MEMORANDUM

To: Megan Fortson, Planner, City of Keene, NH
From: Russell Abell, PG
File: 6741.00
Date: August 15, 2025
Re: Summary of Hydrogeologic Review of G2 Holdings Keene Quarry Expansion Application
cc: Mari Brunner, Evan Clements, Emily Duseau

Figure 1

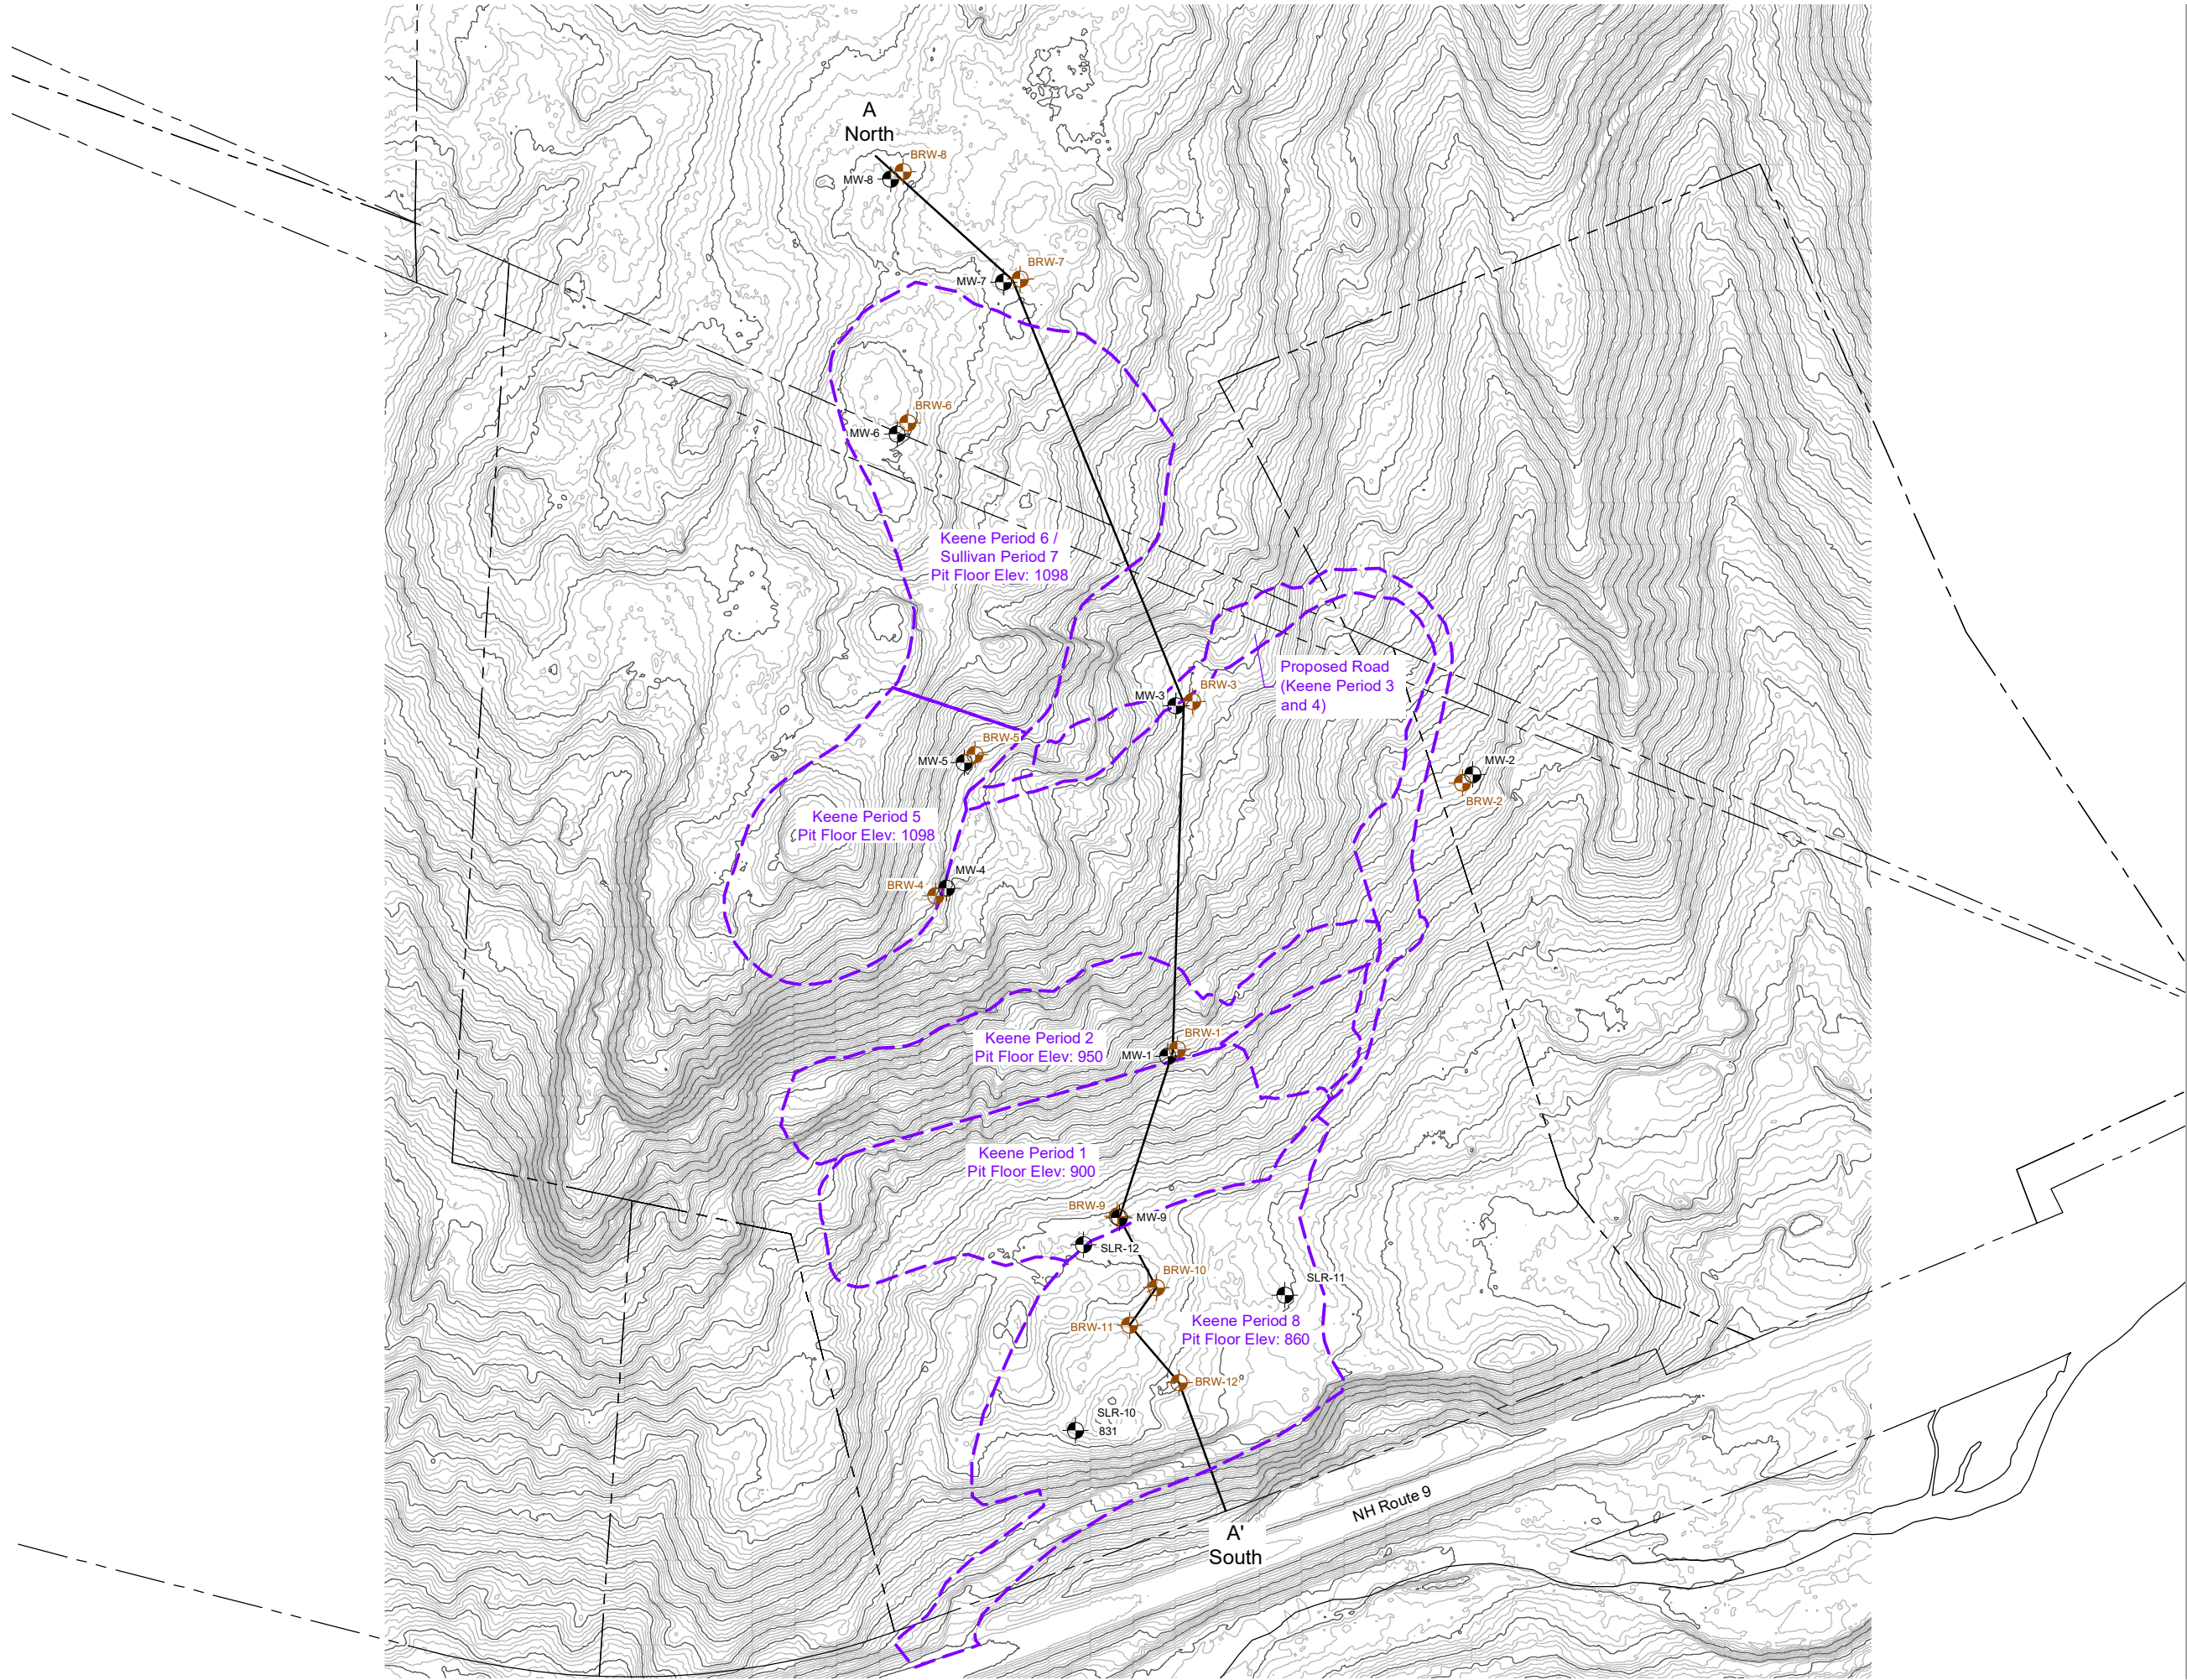
- Groundwater was not observed in monitoring wells installed within or adjacent to Periods 2 through 7, which are the same borings that identified granitic bedrock underlying a thin (<10 feet thick primarily) overburden unit. Refer to Figure 1 for the location of each of the proposed excavation areas (Periods 1-8).

Figure 2

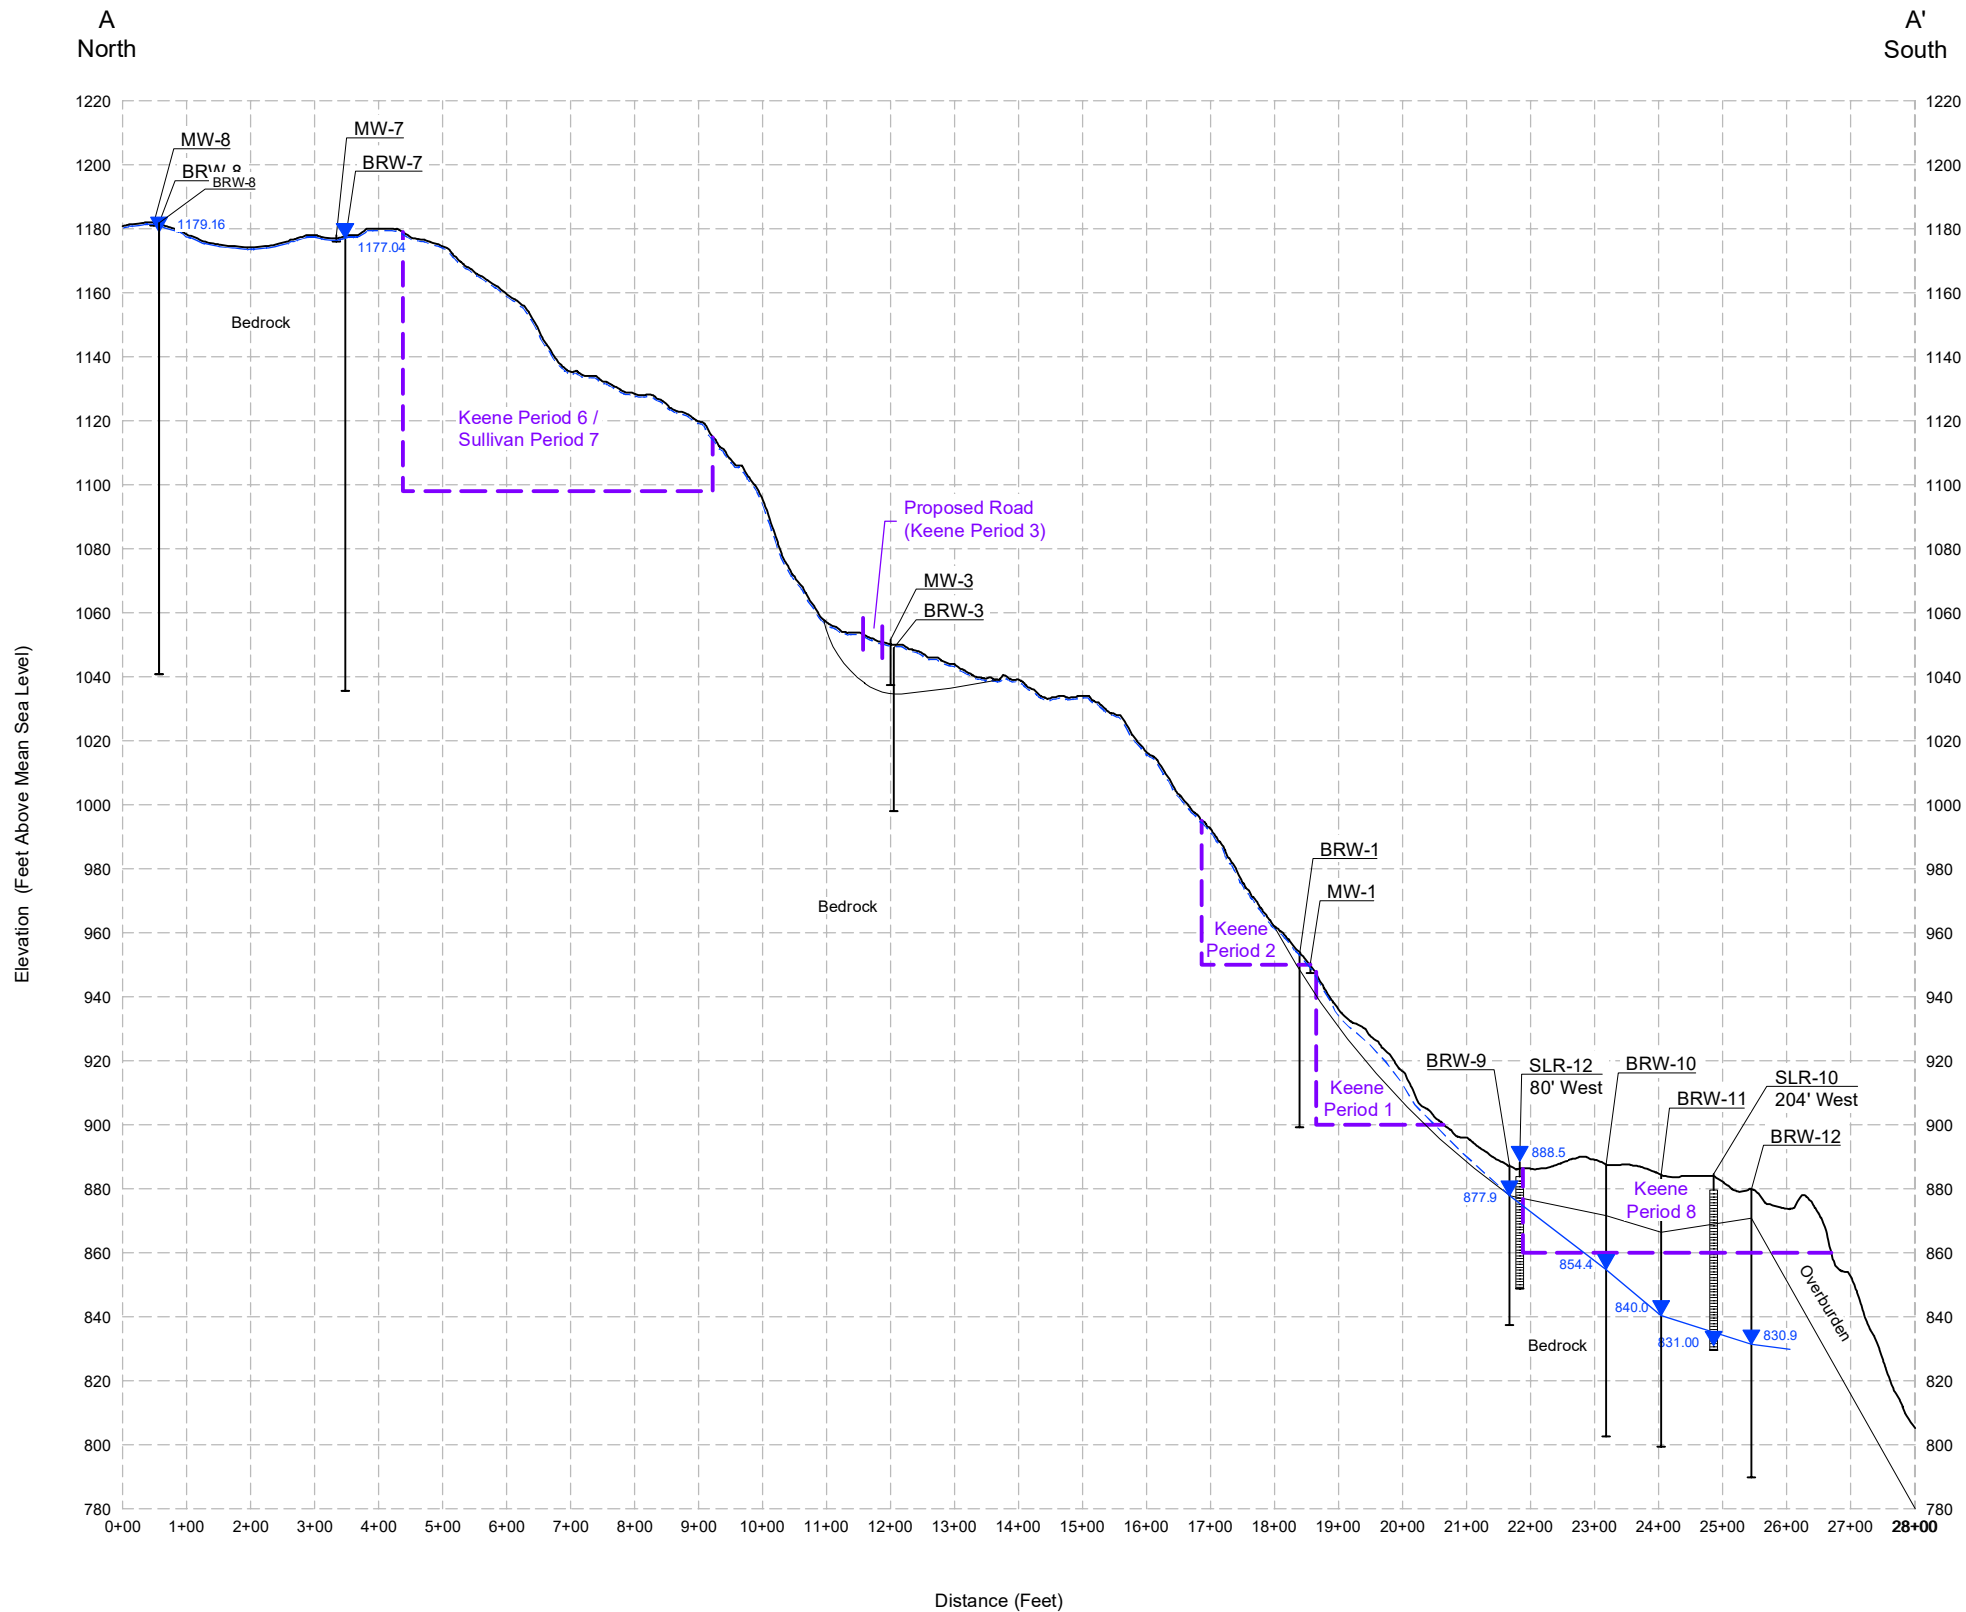
in the northwest portion of the proposed excavation area. In fact, as shown on Figure 2, under current seasonal low water table conditions, the northwest portion of the Period 8 excavation is projected to be below the water table. Seasonal high water conditions may also be a concern for Period 1 as well, especially in the southeastern portion of the excavation area. Additional data collection from Period 1 would be needed to determine the water table conditions there.

- Groundwater was observed in each of the bedrock monitoring wells located adjacent to/in Periods 1 and 8 and ranged from approximately 1.5 feet below ground surface to approximately 55 feet below ground surface. Sanborn Head prepared a vertical profile across the Site to better visualize and evaluate the water table or groundwater elevations, which is provided as Figure 2. Figure 2 shows that, consistent with the topography of the Site, the water table is shallower adjacent to Period 1 and the water table elevation decreases across Period 8 towards Otter Creek (located east – northeast of the Site).

- As shown on Figure 2, the revised proposed excavation floor elevation (860 feet AMSL) in Period 8 is interpreted to be above the seasonal low water table elevation in the northwestern portion of this area. In addition, during seasonal high water table elevation conditions, it is possible that the revised excavation pit floor elevation (900 feet AMSL) in the southeastern portion of Period 1 may also be below the water table elevation. However, the groundwater elevation observed in monitoring well SLR-12 in March 2022 was approximately 888.5 feet AMSL, which is more than 6 feet below the proposed pit floor elevation of 900 feet AMSL. This monitoring well is located near the southeastern boundary of Period 1 and there is not additional data within Period 1 to evaluate the groundwater elevation in this area.

Based on the above information, Sanborn Head also concludes that at the revised excavation pit floor elevations in Periods 1 (900 feet AMSL) and 8 (860 feet AMSL), groundwater is likely to be encountered during seasonal high water conditions in Period 1 and potentially throughout the year in Period 8. Therefore, it is recommended that the planned excavation area/depth in Period 8 be modified or the Applicant would need to seek a waiver of LDC Article 25.3.3.B. If a waiver is sought, additional requirements would be necessary due to the presence of domestic drinking water wells within ½ mile of the Site including, but not limited to, additional monitoring well installations, a pumping test, and other requirements. It is recommended that the Application install one or more bedrock monitoring wells within Period 1 to better understand the water table conditions in this area.
